ADDENDUM #3 – APRIL 15, 2025

RE: CITY OF COQUILLE URA
N. Adams Street Improvements Phase 1:
Underground Improvements
Project #23.81

FROM: HGE ARCHITECTS, Inc.
333 South 4th Street
Coos Bay, Oregon 97420
541-269-1166

SL-2

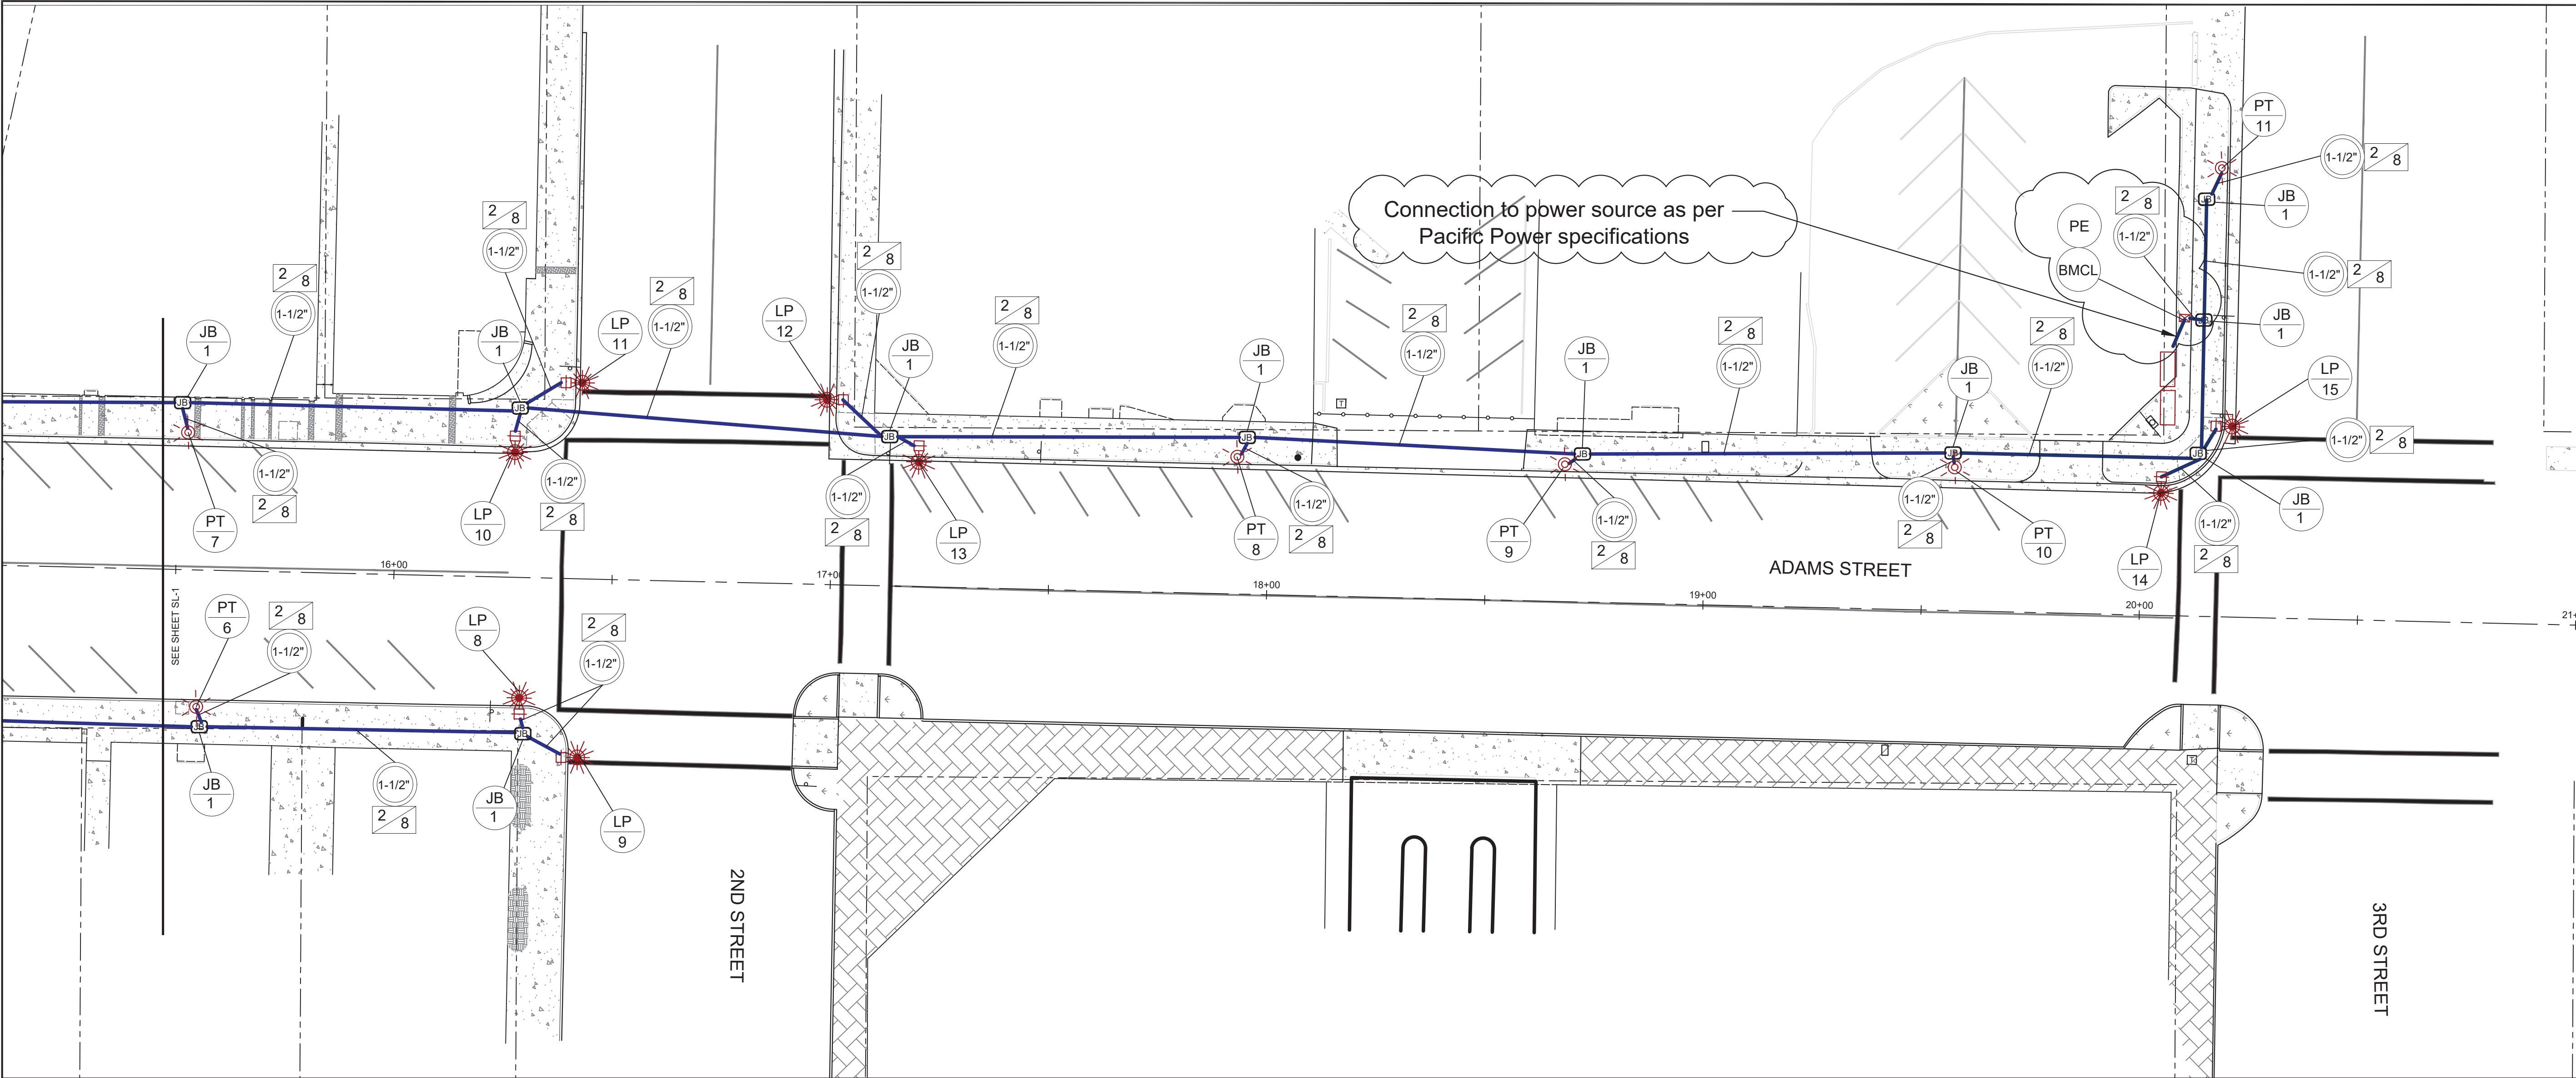
1. **Sheet SL-2 Street Lighting:** REPLACE sheet with attached revised sheet.
 - a. **Revision Summary:** REVISED to show location of Street Light Service Cabinet at Coquille Public Library. Changes include the addition of the base mounted service cabinet and photo electronic control relay on cabinet, one additional junction box, conduit, and wiring.
2. **Sheet SL-6 Street Lighting, Controller Cabinet and Service Cabinet Details:** ADD attached sheet.
3. **Sheet SL-7 Street Lighting, Service Cabinet Wiring Details:** ADD attached sheet.
